From: Andrew.Clout <Andrew.Clout@horsham.gov.uk>
Sent: 03 March 2026 09:34:30 UTC+00:00
To: "Halima.Chowdhury" <Halima.Chowdhury@horsham.gov.uk>
Cc: "Trees" <trees@horsham.gov.uk>
Subject: FW: DC/25/2149, Jarvis, Jarvis Lane, Steyning,
Attachments: Jarvis_Typical section through driveway.pdf

Erection of a single storey in-fill extension to rear elevation. Repair, restoration, selective alterations, including window repairs/replacements. Construction of a new driveway, and associated works (Householder).

POROUS PAVER/GRAVEL GRID WEARING COURSE

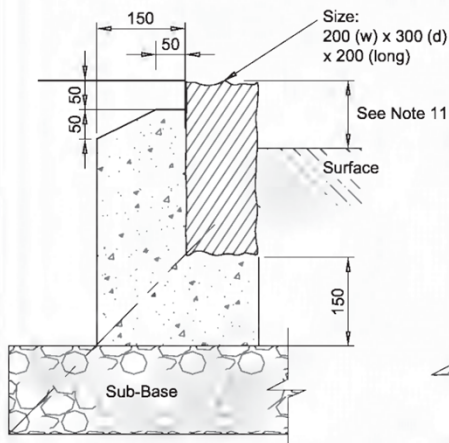
For the main run of driveway up to the parking area the detailing would be best taken from this Core product sheet, (please see the link below), there are a number of similar products on the market, however the images in their brochure are very good, it would be advisable to specify the 150mm base TRP panel as the CBR is unlikely to be above 3.

A 10/14mm natural stone shingle aggregate to provide the finished wearing course and a tanilised wooden edging providing the edge restraint (minimum thickness 22mm)

The same system can be used in the parking area itself as it minimises excavation here, in this area it could be excavated to a more suitable level (finished level 100mm below EGL to allow for a suitable natural stone edging which could have a 150mm concrete foundation (see granite sett detail below)

Support for the change in levels can be made using this system, however in the area which is not required to be a no dig option and there is substantial change in levels it would be more viable with gabions filled with a suitable natural stone and then infill with a porous stone.
